PRODUCT TECHNICAL BULLETIN #96

verSI twinax cable conductor and shield
termination change

Product Lines: verSI™

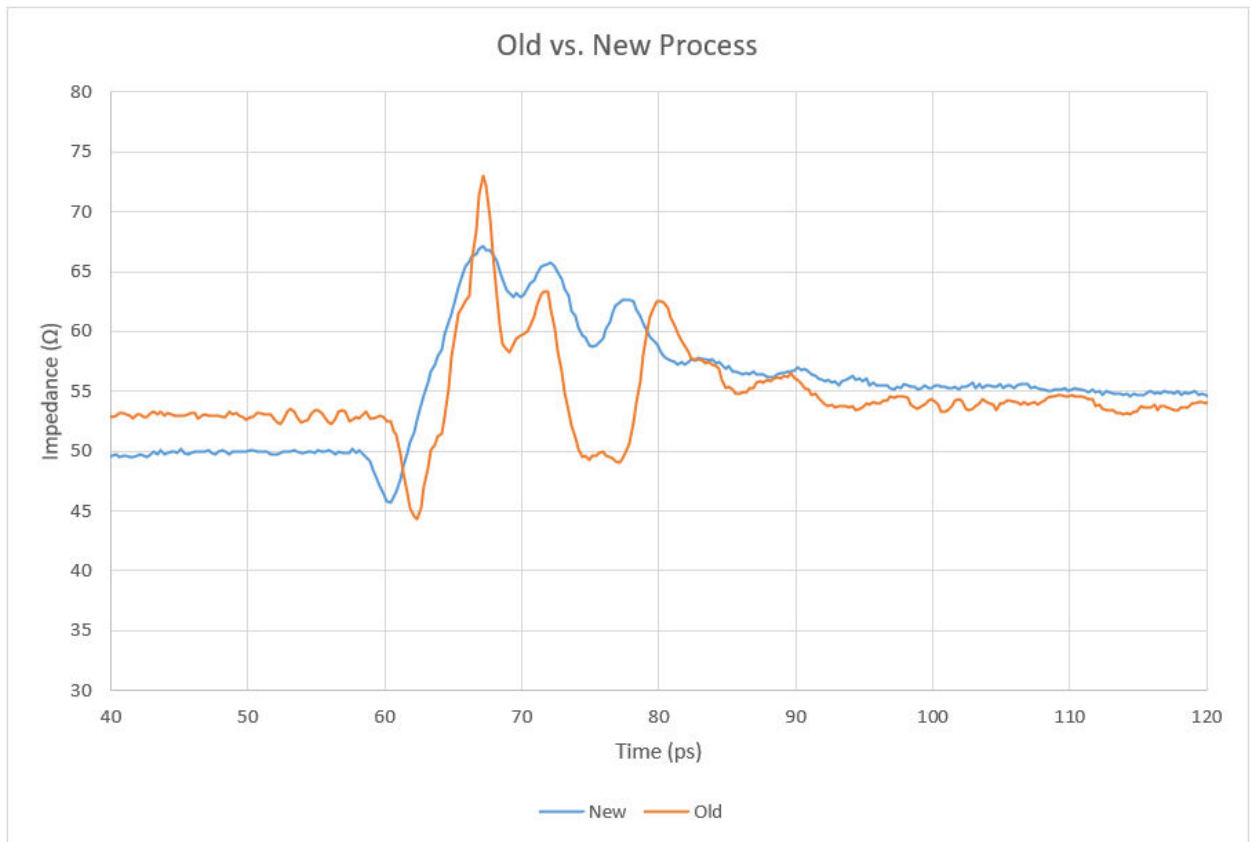
TDR measurements with a rise time of 7 ps show the new construction has an impedance that is smoother and more consistent than before, including a smaller impedance drop at the soldered termination and a smaller initial impedance spike at the verSI connection.
